## Riley Purgatory Bluff Creek Watershed District Permit Application Review

**Permit No:** 2022-076

**Project:** Tricam Addition – The applicant proposes the expansion of an existing building, improvements to onsite sidewalks, additional parking areas, and the addition of a pickleball court on the site. Stormwater management includes a subsurface stormwater management facility to provide volume control, water quality, and rate control.

SW1.0

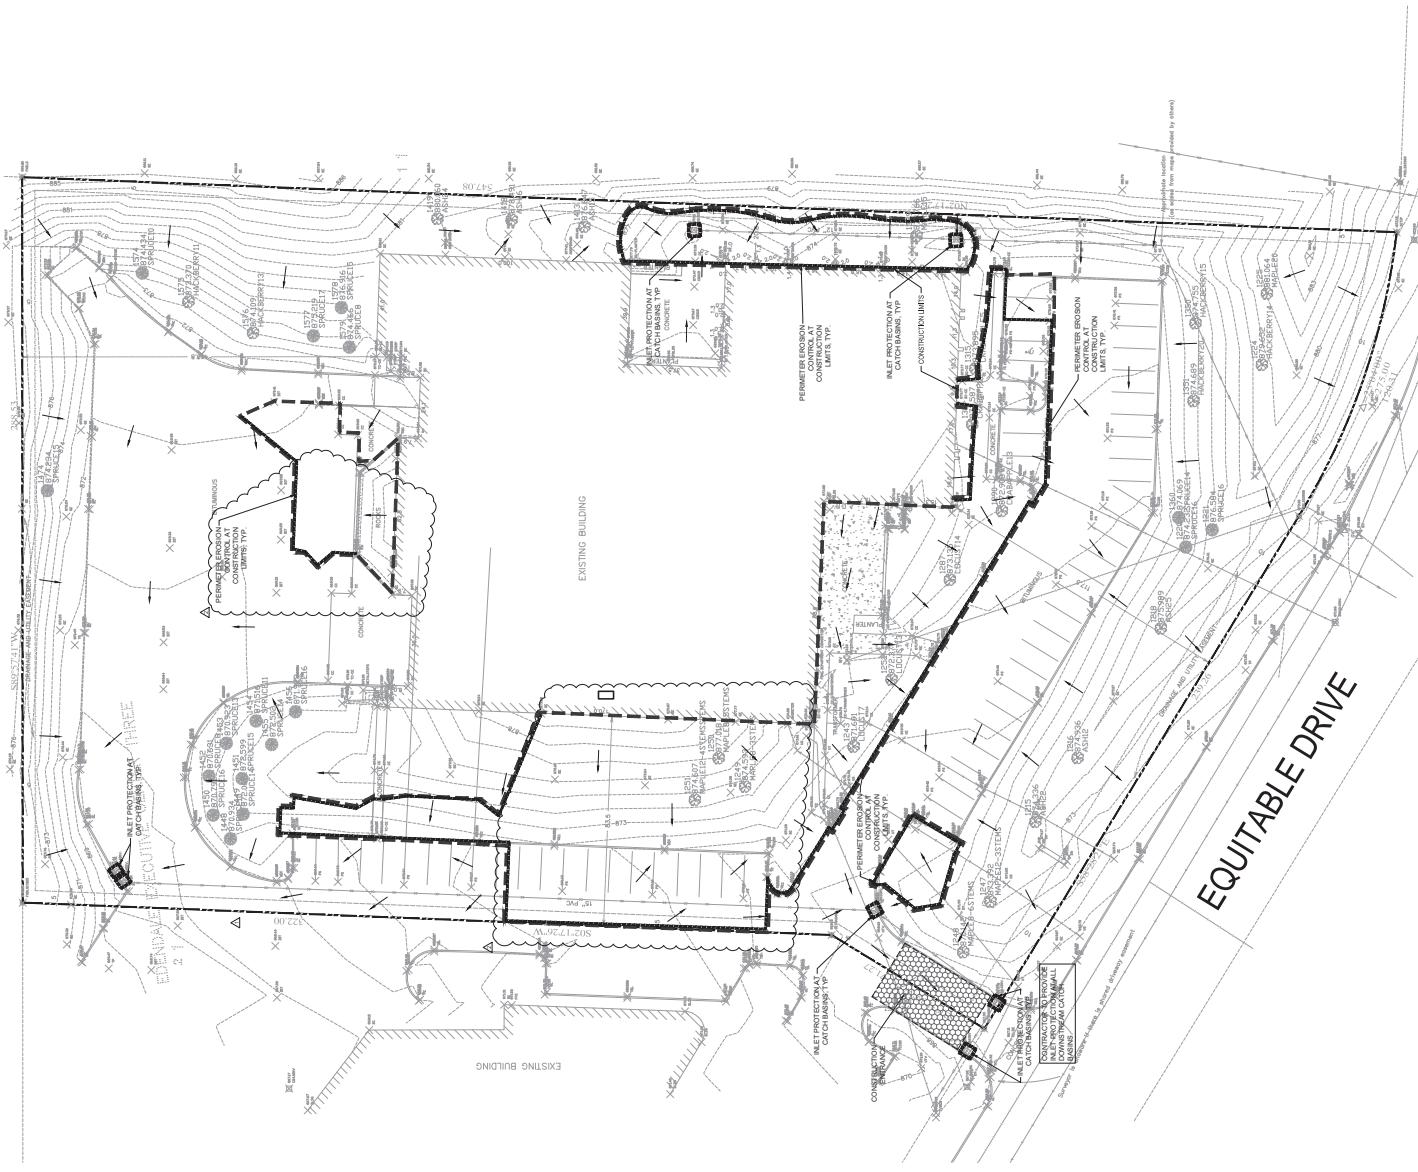
The erosion and sediment control plans prepared by Civil Site Group include installation of silt fence, rock construction entrance, erosion control blanket, placement of a minimum of 6 inches of topsoil, construction sequencing, decompaction of pervious areas compacted during construction, and retention of native topsoil onsite. To conform to RPBCWD Rule C requirements the following revisions are needed:

- C1. The Applicant must provide the name and contact information of the individual responsible for erosion control at the site. RPBCWD must be notified if the responsible individual changes during the permit term.
